# MARANTZ SERVICE BULLETIN

model number 16	bulletin number 69-12/16-1	date 9-25-69
for serial numbers 16-1001	to 16-3000	
subject MODIFICATION TO BE PERFORMED

## Addendum for Model 16 (80 RMS 80)

Service Manual #199-1003,  
dated September 17, 1969.

Figure 14. Marantz Model 16 Power Amplifier, Schematic Diagram.

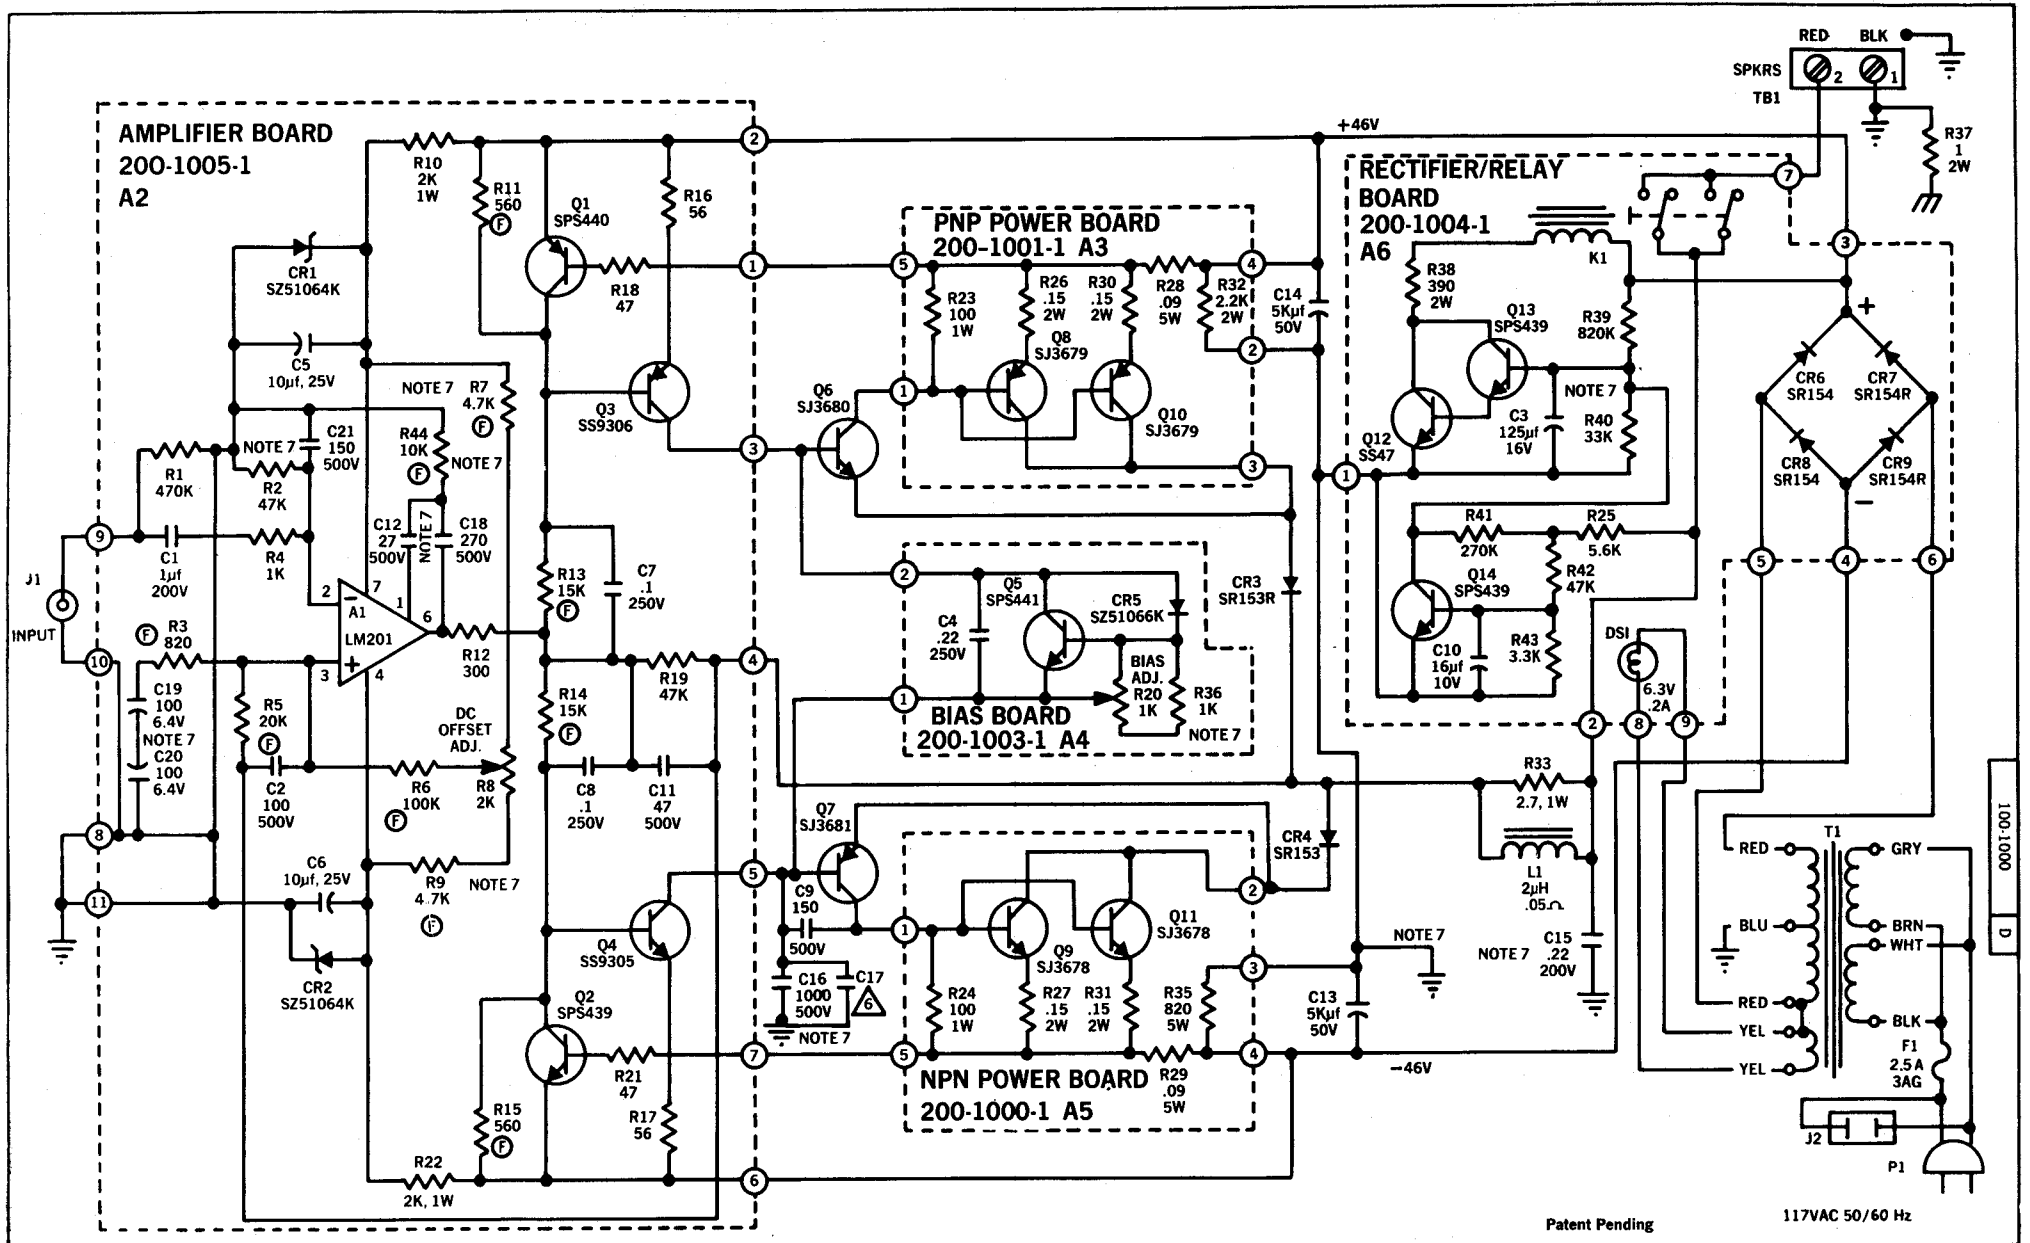
1. Insert change in following places: Figure 2, page 3; Figure 5, page 7; and Figure 14, page 21. Capacitor C8 was 0.1  $\mu$ f 250 VDC, is 0.022  $\mu$ f 100 VDC per E.C.N. 1097 and Marantz service bulletins 69-12/16-1 and 69-16/16-3.

6. On Figure 14, page 21, add capacitor C23, 300 pF, 500 V across R44, 10K.
7. On CHANGE RECORD add:  
E.C.N. no. 1097 (item 1)  
(Added: C23. Changed C8).  
Dated: September 23, 1969.  
Effectivity: S/N 1456, on.

8. Resistor R37 is 1.2 ohms. The callouts for this value should be corrected in the following places: Figure 1, page 2; Figure 14, page 21.
9. Disregard all sine-wave symbols on Figures 1, 2, 4 and 5. They are not always correct.
